ADDENDUM NO.2 DATE: July 11, 2014

Contract: 14-C-00009; Krause Pump Station Rehabilitation.

SHEET M-4

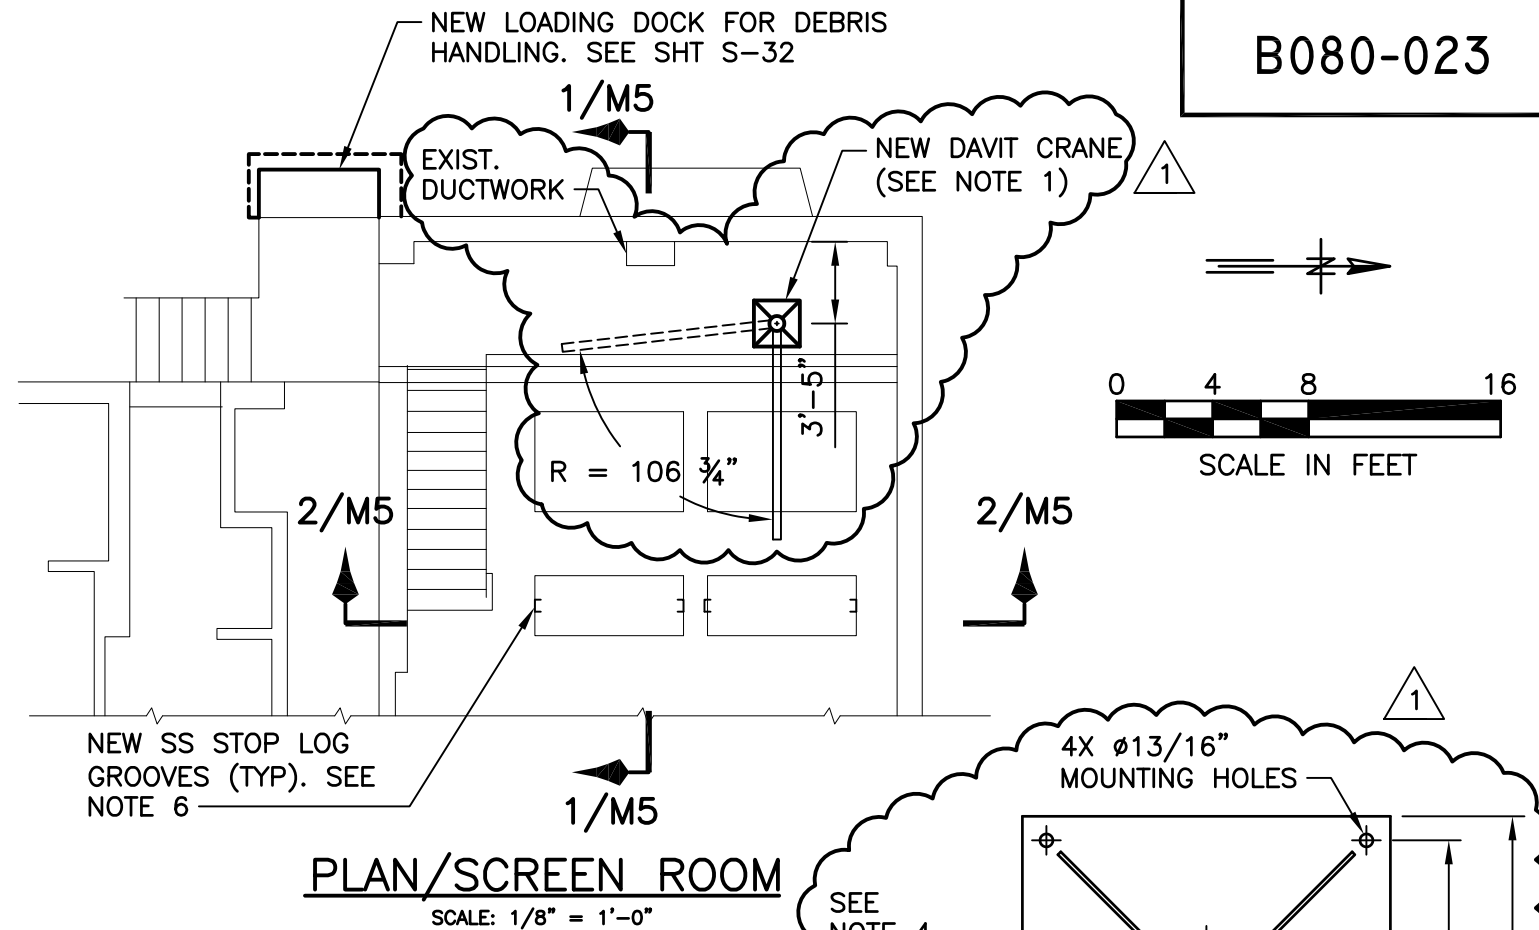
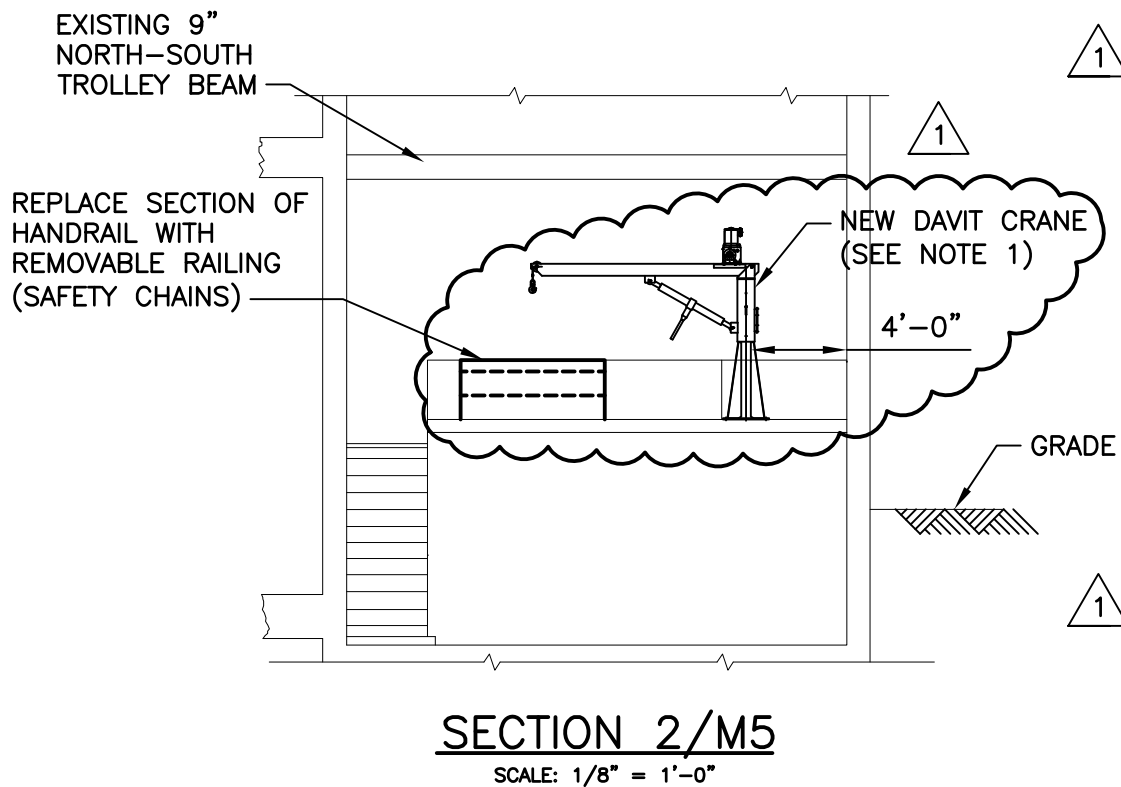
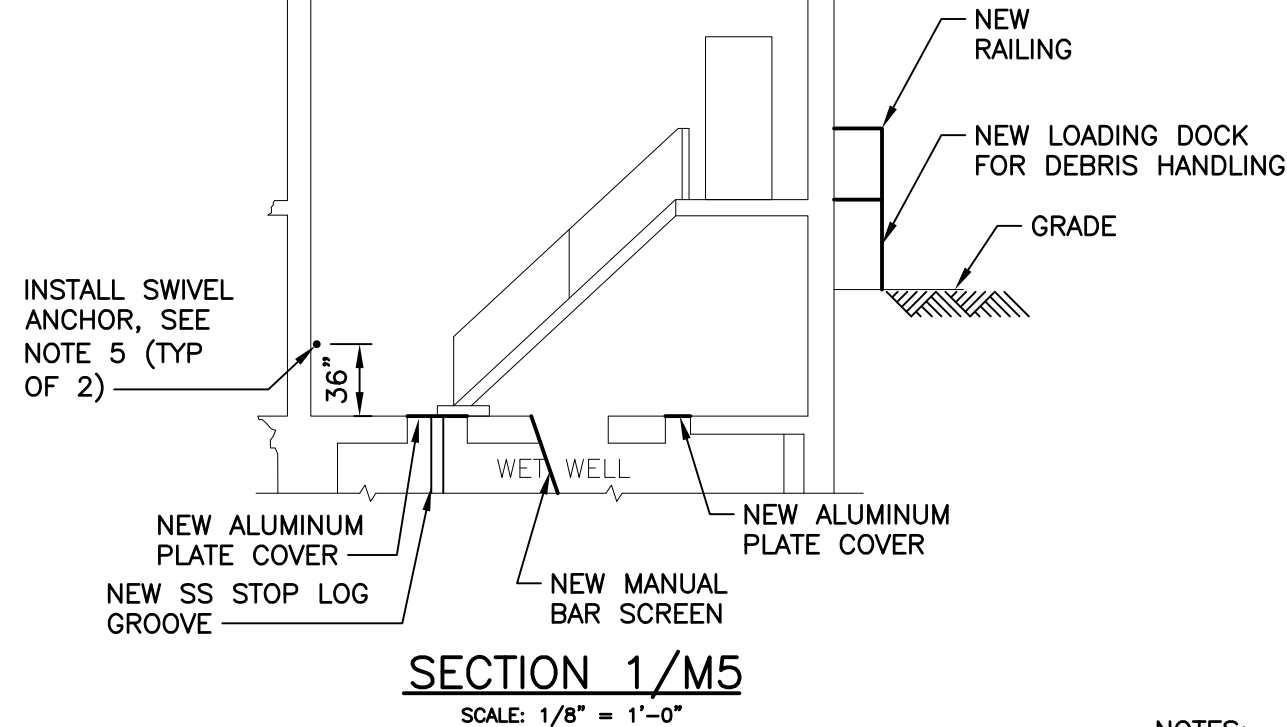
- Item 1: I-1.05 of the Instructions to Bidders, revise the time for completion to be 630 days.
- Item 2: Replace Workmanship and Materials Section 24 Painting, with the attached Section 24 Painting.
- Item 3: Add the attached Section 40 70 10 Field Instruments and ABB Standardization Certificate.
- Item 4: Sheet I-2, Proposed Annunciator Riser Diagram and Partial Equipment Back Panel Layout - Clarification: The 7" Maple System HMI part number HMI5070TH (Ethernet communication) is an acceptable alternative to the 7" Maple System HMI part number HMI5070NH.
- Item 5: Replace plan sheets M-4 and M-7 with the attached plan sheets M-4 and M-7.
- Item 6: Delete plan sheets S-36 and S-37.
- Item 7: Add the following note 19 to plan sheet G-1:

7/3/14	REVISED EQUIP AND NOTES
NO.	DATE	REVISIONS

SHEET M-7

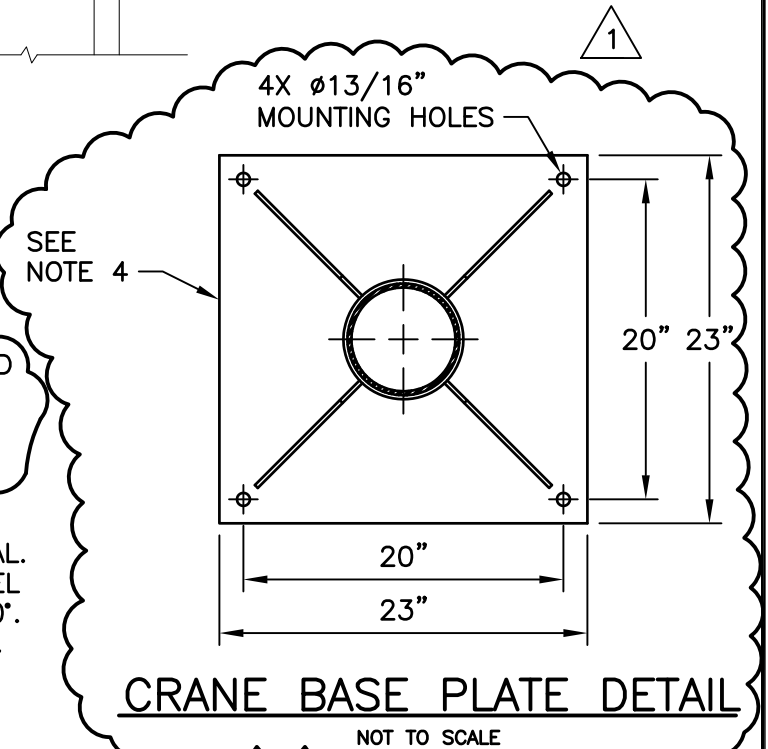
NO.	DATE	REVISIONS
1	7/3/14	REVISED EQUIP AND NOTES

1. INSTALL NEW THERN SERIES 572 DAVIT CRANE (MIN. 1,700 LB LOAD RATING) TO INCLUDE PNEUMATIC WINCH - 572E3PN, ADJUSTABLE SCREW JACK SJ2, PNEUMATIC CONTROLS - 477PN - CNTRL, PNEUMATIC WINCH HOSES - 477PN-HS6, AND A MINIMUM OF 36 FEET OF 5/16" DIA. 304 STAINLESS STEEL WIRE.

2. INSTALL TO 5K HYBRID MEGA SWIVEL ANCHORS OR APPROVED EQUAL. INSTALL ANCHORS IN CONCRETE WALL FOR FALL PROTECTION. SWIVEL ANCHORS SHALL BE CAPABLE OF ROTATING 360° AND FLIPPING 180°. LOCATION OF ANCHORS TO BE COORDINATED WITH CITY PERSONNEL.

3. SECURE SS STOP LOG GROOVES TO EXISTING CHANNEL WALLS WITH HILTI COUNTERSUNK STAINLESS STEEL SS316L KWIK BOLT 3 ANCHORS (C3/8X4) SPACED AT 4 INCHES ON CENTER. INSTALL ANCHORS PER MANUFACTURER'S RECOMMENDATIONS. PRE-DRILL WALL SURFACE MOUNTED STAINLESS STEEL STOP LOG CHANNEL TO ACCOMMODATE COUNTERSUNK ANCHOR HEAD. ANCHORS ARE DESIGNED FOR WATER DEPTH OF 20 FEET MAXIMUM.

4. ANCHOR USING 3/4" DIAMETER HILTI RODS (AISI GRADE 304/316 STAINLESS STEEL) OR APPROVED EQUAL. EMBED RODS 8-3/4" FROM TOP OF FINISHED SLAB. ADHERE RODS WITH HILTI HIT-RE 500 EPOXY. INSTALL RODS AND EPOXY PER MANUFACTURER. ASSUME SLAB TO BE 8-INCHES THICK WITH 2-INCHES CONCRETE TOPPING.
